## KENTUCKY POWER COMPANY (“KPC”)

### 2020 INTEGRATED RESOURCE PLAN

CASE NO. #2019-00443

#### COMMENTS OF THE SOUTHERN RENEWABLE ENERGY ASSOCIATION

**Figure 29. Large-Scale Solar Pricing Tiers with Investment Tax Credits**

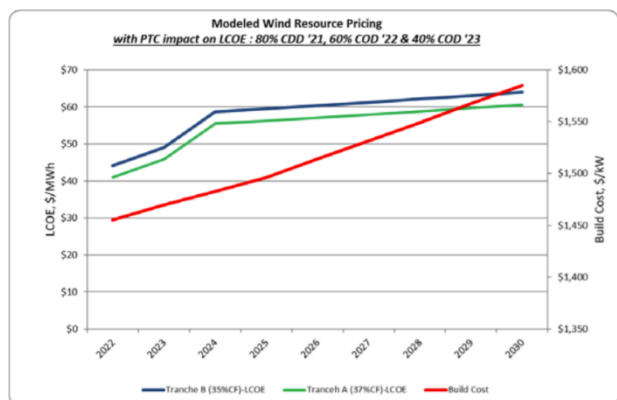
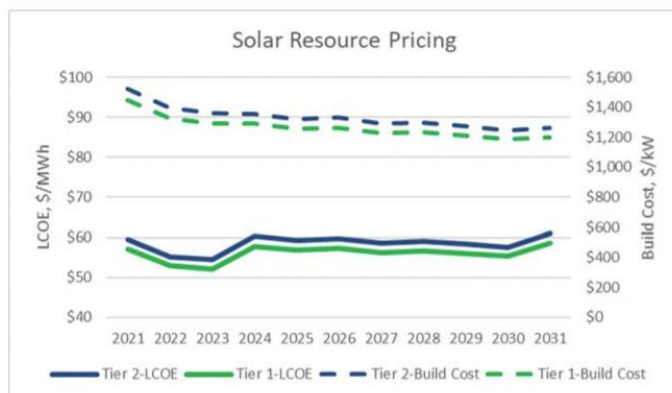
KPC evaluated two "tiers" of wind energy resources and two tiers of solar energy resources. KPC's data assumptions are nearly \$50/MWh in 2023 and \$60/MWh in 2024 for both wind and solar resources. These cost assumptions for renewable energy resources are approximately 200% higher than current market offerings and anticipated near-term forecasted prices. KPC's cost assumptions for renewable energy resources are flat to increasing over the next decade, which at face value, is contrary to all reasonable forecasts. The two tiers for both wind and solar resources are virtually the same and represent only about a 10% pricing difference; this is not a robust sensitivity test. By using artificially inflated renewable energy pricing, KPC's modeling efforts in this IRP are overestimating the cost of renewable energy resources, and underestimating the near-term savings associated with large scale renewable energy procurement.

SREA recommends that KPC use the National Renewable Energy Lab's (NREL) Annual Technology Baseline (ATB) for renewable energy and energy storage cost assumptions. NREL's ATB data is free to use and considered industry standard because it reflects recent market offerings for renewable energy resources. For example, NREL's 2020 ATB shows solar and wind energy resources for a levelized cost of energy (LCOE) of approximately \$30/MWh.<sup>2</sup> These values do not include the federal production tax credit (PTC) for wind energy, nor the federal investment tax credit (ITC) for solar energy, which would decrease these costs further.

**Figure 27. Energy Storage Installed Cost**

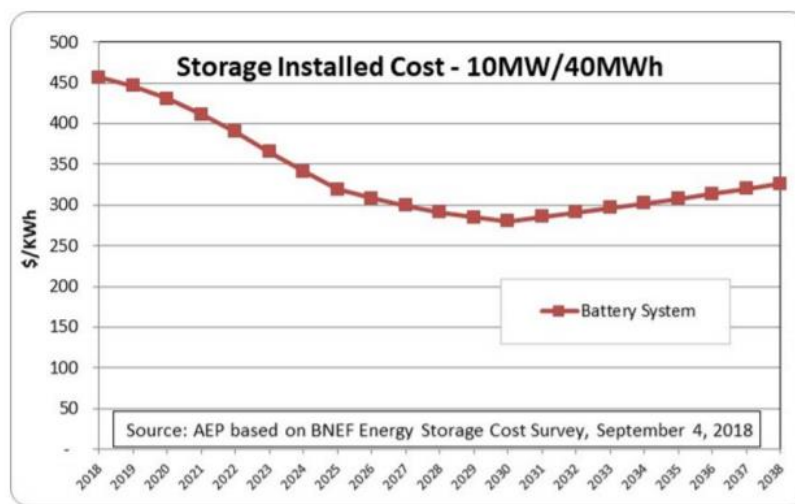
KPC notes that “The [battery] storage resource characteristics and cost were updated in early 2019.” However, Figure 27 shows that the energy storage installed cost values are from BNEF in 2018. Also, the data provided to stakeholders states pricing forecasts are from “Update: 10/22/2018 - Tesla/BNEF”.<sup>21</sup> It is unclear if the pricing provided in the IRP are overnight capital costs, and what all cost variables are included in the assumptions. Based on the provided information, it appears that the costs used by KPC are higher than current market offerings.

For example, as mentioned previously in these comments, an RFI response in South Carolina showed adding energy storage may cost between \$210-\$375/kWh in 2022, with various energy configurations.<sup>22</sup> Along with renewable energy pricing, the NREL ATB also provides pricing forecasts for both 4-hour and 2-hour energy storage projects.<sup>23</sup> Compared to NREL ATB, KPC’s energy storage cost assumptions are 20-30% higher than a moderate forecast for 4 hour battery storage systems. NREL’s ATB data align very well with the data provided through Santee Cooper’s RFI.

Source: KPC 2020 Attachment 1<sup>30</sup>

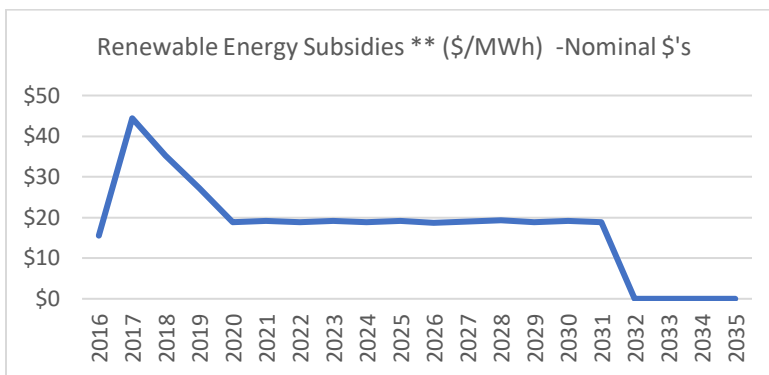
KPC does include cost reductions associated with the federal Production Tax Credit (PTC) and Investment Tax Credit (ITC) for renewable projects; however, the IRP narrative does not seem to match data provided to stakeholders. In the Excel file KPCO\_R\_KIUC\_1\_09\_Attachment1 (“Attachment 1”), Column AZ in spreadsheet “Annual-Prices Nominal” shows “Renewable Energy Subsidies \*\* (\$/MWh) -Nominal \$’s”.<sup>29</sup> When charted, those data show a flat subsidy from 2020-2031, with no benefit after 2031. The data in Attachment 1 do not appear to match Figure 29 Large-Scale Solar Pricing Tiers with Investment Tax Credit, nor Figure 31 Levelized Cost of Electricity (LCOE) of Wind Resources (Nominal \$/MWh). According to Figures 29 and 31, both wind and solar resources are anticipated to slowly increase in cost over the next few years as tax credits are phased out; however, Attachment 1 suggests the effects of the federal tax credits have

already expired in the 2020-2030 timeframe. Further, KPC states that, “The ITC benefit is included through 2030. At this point in time, the 10% ITC benefit would become indiscernible from potential variations in forecasted prices.” But based on the information in Attachment 1, it appears KPC simply eliminated the ITC after 2030, despite continued anticipated savings. Further, the cost savings associated with the ITC are based on total capital cost and should be different based on different technology groups; as such, it is unclear if the Attachment 1 applies to wind, solar, and/or hybrid resources. SREA requests KPC provide clarification regarding how tax credits are applied in modeling.
